Technical Service Bulletin

40 Rumbling/creaking noises from front of vehicle while driving

40 18 83 2048266/3 July 30, 2018. Supersedes Technical Service Bulletin Group 40 number 17-75 dated September 20, 2017 for reasons listed below.

Figure 1. Hydro-bushing.

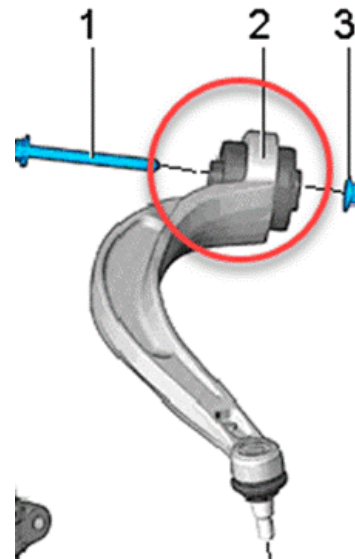
The noises can be generated on the lower left control arm in the area of the hydro-bushing.

Modified hydro-bushing in control arm link (Figure 1):

- A6/A7 - 4G4HN011283 on 06/21/2016, part number 4G0407183B
- A8 - 4H7HN000731 on 06/01/2016, part number 4H0407183C
- Q7 - 4M2GD063812 on 04/29/2016, part number 4M0407183B

Check the lower guide link of the front axle as it may be the source of the noises. If necessary, replace the hydro-bushing on the guide link.
